Access Compliance Report Public Rights-of-Way (Curb Ramps)

Intersection ID: 2865 Main Street: DOWNFIELD WOOD DR Cross Street: LADY BANK DR Location: **Overall Compliance: No** ADA ID: 4F191C1E0DFB Ramp Type: Perp Initial Pass/Fail: Fail Severity Score: 33.75

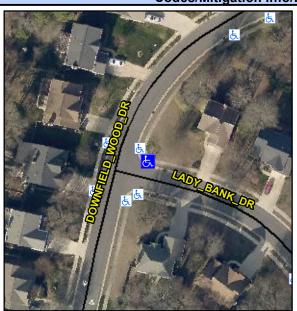
LADY BANK DR Street 1 Name Stop Condition-Street 2 StopSign N/A Street 2 Name Stop Condition-Street 1 N/A Possible Solutions: Remove & Replace Entire Ramp. Surveyor Notes: N/A PROW/ADA: R304.5.1, R304.5.3

Compliance Description Data Compliance Description Data Yes Ramp Slope (%) N/A Ramp Length (in) 49.0 5.0 No Ramp XSlope (%) No Ramp Width (in) 38.0 7.4 N/A Flare Type LT N/A N/A Flare Type RT N/A N/A N/A N/A Flare Slope RT (%) N/A Flare Slope LT (%) N/A Flare Traversable LT? N/A N/A Flare Traversable RT? N/A N/A N/A N/A **DWS Provided?** N/A Landing Length (in) N/A Landing Width (in) N/A N/A **DWS Contrast?** N/A N/A N/A N/A Landing Slope (%) DWS Length (in) N/A N/A Landing X Slope (%) N/A N/A DWS Full Width? N/A N/A Landing Curb? (Y/N) N/A N/A DWS Offset (in) N/A N/A N/A Shared Landing? N/A **Gutter Ponding?** N/A N/A Gutter Slope (%) N/A N/A Gutter Lip Ht (in) N/A N/A Gutter X Slope (%) N/A N/A Painted X Walk1? No N/A Painted X Walk2? N/A X Walk 1 Direction To S X Walk 2 Direction N/A N/A N/A X Walk 1 Width (in) N/A X Walk 2 Width (in) N/A X Walk 1 Slope (%) 7.0 X Walk 2 Slope (%) N/A X Walk 1 X Slope (%) 6.0 X Walk 2 X Slope (%) N/A N/A N/A N/A Ramp inside XWalk2? Ramp inside XWalk1? N/A Road Slope (%) N/A N/A Clear Space? N/A Road X Slope (%) N/A N/A Clear Space to XWalk (in) N/A N/A N/A Any Obstructions? N/A Storm Grate/Utility Hazard? N/A **Obstruction Type** Storm Grate/Utility Type N/A N/A
